Access Compliance Report

Public Rights-of-Way

(Curb Ramps)

Intersection ID: 25829	Main Street: GREYSON RIDGE DR	Cross Street: HIGH RIDGE RD	Location: NE
ADA ID: 4C2F858E096D	Ramp Type: Perp	Initial Pass/Fail: Fail	Overall Compliance: No
Severity Score: 21.25			
Codes/Mitigation Info/Possible Solution		Field Measurements/Component Compliance

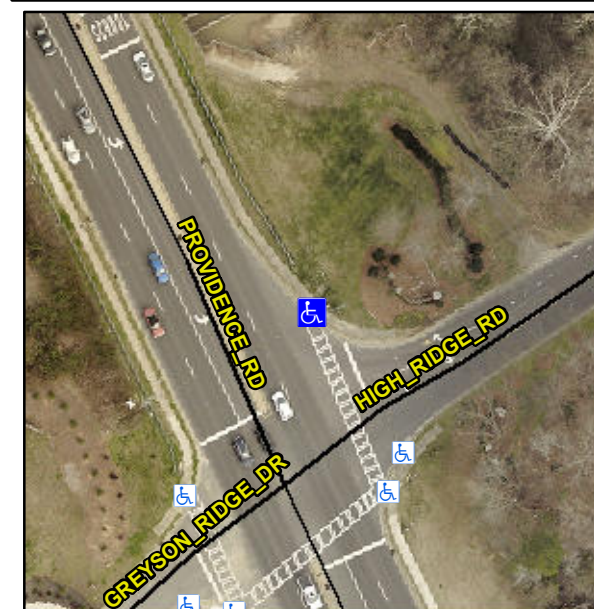
Not Found, R304.5.1, R304.2.2

Compliance	Description	Data	Compliance	Description	Data
N/A	Ramp Length (in)	73.0	No	Ramp Slope (%)	8.5
No	Ramp Width (in)	47.0	Yes	Ramp XSlope (%)	1.5
N/A	Flare Type LT	N/A	N/A	Flare Type RT	N/A
N/A	Flare Slope LT (%)	N/A	N/A	Flare Slope RT (%)	N/A
N/A	Flare Traversable LT?	N/A	N/A	Flare Traversable RT?	N/A
N/A	Landing Length (in)	N/A	N/A	DWS Provided?	N/A
N/A	Landing Width (in)	N/A	N/A	DWS Contrast?	N/A
N/A	Landing Slope (%)	N/A	N/A	DWS Length (in)	N/A
N/A	Landing X Slope (%)	N/A	N/A	DWS Full Width?	N/A
N/A	Landing Curb? (Y/N)	N/A	N/A	DWS Offset (in)	N/A
N/A	Shared Landing?	N/A			
N/A	Gutter Ponding?	N/A	N/A	Gutter Slope (%)	N/A
N/A	Gutter Lip Ht (in)	N/A	N/A	Gutter X Slope (%)	N/A
N/A	Painted X Walk1?	Yes	N/A	Painted X Walk2?	N/A
	X Walk 1 Direction	To S		X Walk 2 Direction	N/A
N/A	X Walk 1 Width (in)	75.0	N/A	X Walk 2 Width (in)	N/A
	X Walk 1 Slope (%)	2.2		X Walk 2 Slope (%)	N/A
	X Walk 1 X Slope (%)	3.2		X Walk 2 X Slope (%)	N/A

Remove & Replace Entire Ramp.
